ARM920T Rev.1v4 Errata List

Document number: ARM920T-PRDC-000574 2.0
Date of Issue: 17th December 2001
Author: Peter Middleton
Authorized by: Jason Ackroyd

This document describes the known errata in the ARM920T Rev1 v4 design.

4.1 Boundary Scan Cell Enable Transition During JTAG Reset (ARM9TDMI – 4)

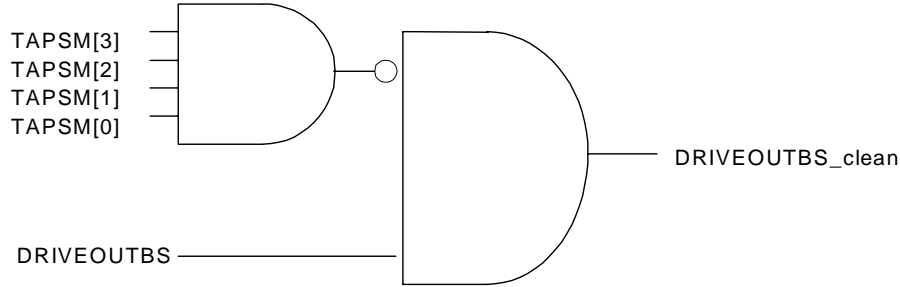
If the JTAG TAP controller within the ARM9TDMI is reset, DRIVEOUTBS may be asserted incorrectly. If the DRIVEOUTBS signal is used to control the multiplexers in the scan cells of an external boundary scan chain then the boundary scan chain cells may be incorrectly controlled.

If the TAP controller state machine is made to enter the reset state by holding TMS high whilst its current instruction is INTEST, EXTEST, CLAMPZ or CLAMP then DRIVEOUTBS will be asserted for one TCK cycle. If the reset mechanism is nTRST then DRIVEOUTBS is driven correctly.

However during debug operation the TAP controller may be reset independently of a system reset. In this case, if TMS is used as the mechanism for causing the TAP controller to enter the reset state then DRIVEOUTBS will be incorrectly asserted. When DRIVEOUTBS is asserted the external scan chains will select the scan path and this could cause incorrect operation of the device.

The following external logic should be added to ensure correct operation of DRIVEOUTBS.

`DRIVEOUTBS_clean = (TAPSM != 4'b1111) & DRIVEOUTBS`

4.2 Coprocessor Memory Transfer incorrectly marked as being sequential (ARM9TDMI – 5)

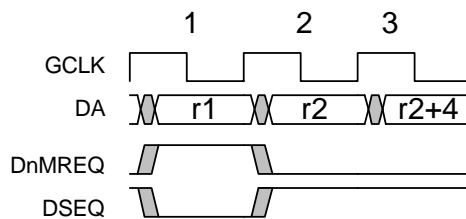
A coprocessor memory transfer instruction (LDC or STC) can incorrectly have its first access (a non-sequential access) marked as being sequential.

For the first memory transfer of any memory instruction the ARM9TDMI should indicate on its data memory request signals that the transfer is non-sequential. This is indicated by DSEQ being low during this first memory access. However there is a particular situation for a LDC or STC instruction where its first memory transfer can incorrectly be marked as sequential. This case can only be invoked if a LDC or STC instruction, which fails its condition codes, is directly followed by a second LDC or STC instruction which passes its condition codes. For the precise conditions required see below.

During cycle (1) in the diagram above, the DnMREQ is high and DSEQ is low, indicating an IDLE cycle. This corresponds to the IDLE cycle generated by the LDC which fails its condition code check. In cycle (2) the first memory transfer for the second LDC occurs. In cycle DSEQ is incorrectly high, marking the transfer as being sequential.

If a coprocessor is attached with can execute LDC or STC instructions then this errata only applies if the coprocessor can execute an LDC or STC without busy-waiting the processor first. Thus a hardware workaround is to ensure all attached coprocessors insert a busy wait cycle before executing a LDC or STC.

A second work around is to ensure that the code does not contain a sequential instruction pair of LDC or STC instructions where it is possible for the first instruction to fail its condition code check and for the second to pass its condition code check.
